DART SERVICE INSTRUCTION

TO AMEND INSTALLATION INSTRUCTIONS D350-607-3 Rev.D,
INSTALLATION INSTRUCTIONS D350-607-4 Rev. C AND
INSTRUCTIONS FOR CONTINUED AIRWORTHINESS ICA-D350-607 REV. 6

REF TCCA STC: SH94-14
REF FAA STC: SR00213NY
REF EASA STC: EASA.10016996
REF BRAZILIAN STC: 2007S03-03/-04/-05/-06

A	NEW ISSUE	AJS	14.05.16
REV.	DESCRIPTION	BY	DATE
DESIGN	AJS	DART AEROSPACE LTD HAWKESBURY, ONTARIO, CANADA	
DRAWN	AJS		
CHECKED	N/A	DRAWING NO.	REV. A
MFG. APPR.	N/A	DSI 9699	SHEET 1 OF 2
APPROVED		TITLE	SCALE
DE APPR.		LUG REPLACEMENT	NTS
DATE	14.05.16	COPYRIGHT © 2014 BY DART AEROSPACE LTD THIS DOCUMENT IS PRIVATE AND CONFIDENTIAL, AND IS SUPPLIED ON THE EXPRESS CONDITION THAT IT IS NOT TO BE USED FOR ANY PURPOSE OR COPIED OR COMMUNICATED TO ANY OTHER PERSON WITHOUT WRITTEN PERMISSION FROM DART AEROSPACE LTD.

FIGURE 1: INSTALLATION OF D4775-041 FWD STRUT

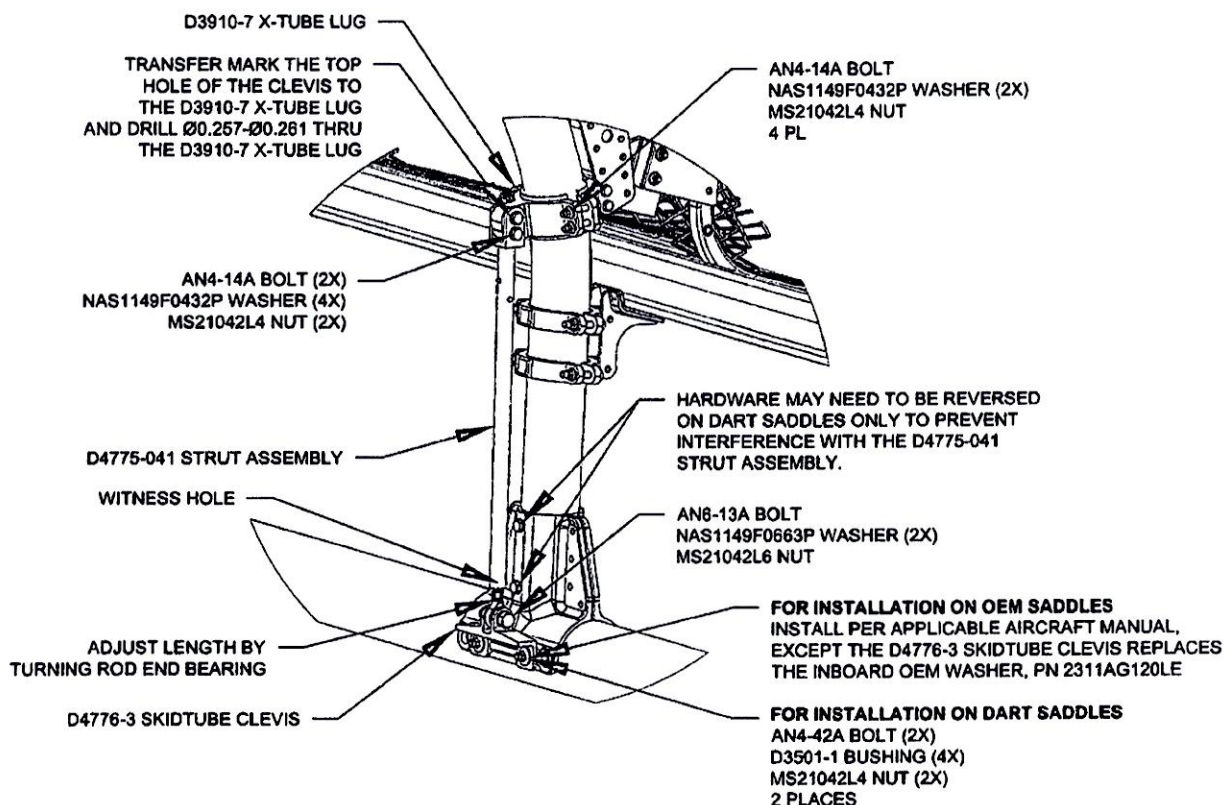
- 3.1 Substitute the Forward Lower D3910-5 X-Tube Lug with the D3910-7 X-Tube Lug as shown in Figure 1.
- 3.2 Install the forward D4775-041 Strut Assembly. Transfer mark from the upper hole on the clevis of the D4775-041 Strut Assembly to the D3910-7 X-tube Lug and drill thru the lug $\varnothing 0.257$ - $\varnothing 0.261$ as shown in Figure 1. Touch up chemical conversion coating per MIL-DTL-5541. Check the witness holes located at the bottom end of the D4775-041 Strut Assemblies to ensure that the thread from the rod end extends past the witness hole.
Torque MS21042L4/-4 nuts to 50-70 in-lbs (5.7-7.9 N-m). Torque MS21042L6/-6 nuts to 160-190 in-lbs (18.1-21.5 N-m).
- 3.3 Complete the installation in accordance with Installation Instructions D350-607-3 Rev. D or D350-607-4 Rev. C.
